## Advanced Thermal Hydronics KN Series H-NET Control Firmware Revision Sheet

### Revision 3.56-57 9-July-2014 Release

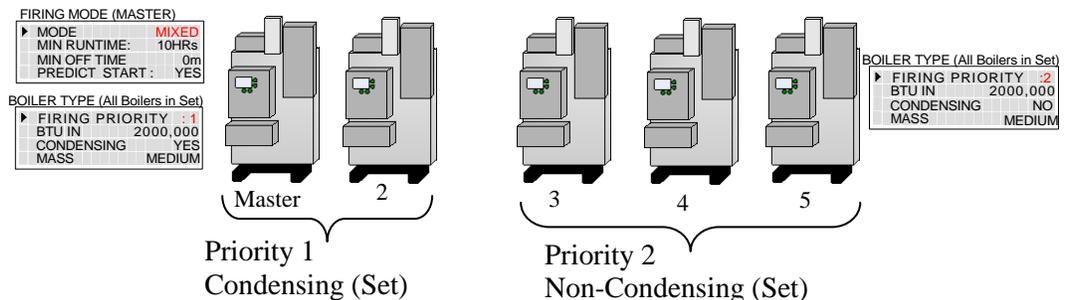
1. The first feature: A MIXED boiler priority method may be used to control condensing and non-condensing, base load, or other boiler sets in a system for optimal performance and economy. A boiler set can be constructed by simply setting the FIRING PRIORITY on each boiler (to be in the set) at the same priority. Setting all (example) condensing boilers to the highest priority of 1, and then setting all (example) non-condensing boilers to a priority of 2, will create (2) sets of boilers, one condensing and the other non-condensing. Once this is done, the set of condensing boilers will have a firing order that has a higher priority and is independent of the other non-condensing set with the lower priority. The boiler set with the highest priority can then be fired based on the conditional settings menu. The lower priority set will follow.

A boiler’s firing priority can be designated as such in: “ADVANCED SETUP:SYSTEM:BOILER TYPE:FIRING PRIORITY : 1” menu on each boiler. A priority of ‘1’ is the highest priority, a ‘2’ the lowest (default is always 2).

In the above example condensing boilers and non-condensing boilers are used, but other combinations may also be used. Another example could use (2) small boilers and set them to Priority 1 and then use (3) large boilers and set them to Priority 2. Using these priority settings (with the conditions menu), the small boilers can run first during the shoulder months and the larger boilers can fire last during the colder season (base loading set).

**Starting Boilers:**

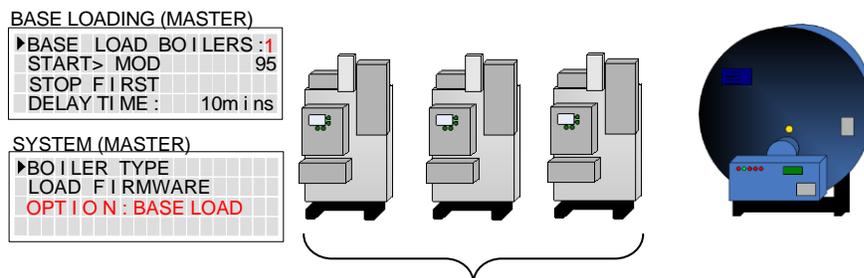
When a boiler is to be fired (water temp is below the heating band), the Master checks the Heat Net boilers it has available. The Master boiler then looks at which boilers are returning priority firing status (set on a boiler in: (ADVANCED SETUP:SYSTEM:BOILER TYPE:PRIORITY : 1). If the Start condition is met (ADVANCED SETUP:FIRING MODE: MODE: MIXED:SET *FIRST(example)*), the Master or Member boiler that is configured as PRIORITY 1, with the lowest runtime, will be fired *FIRST(example)*.. As long as the start condition is met, all PRIORITY 1 set of boilers will fire based on runtime. Once all PRIORITY 1 set of boilers have fired, the PRIORITY 2 set of boilers will fire based on runtime. If the Start condition changes and/or is not met (such as with: OA T or RET temp), the PRIORITY 2 set of boilers will fire first/next based on runtime.
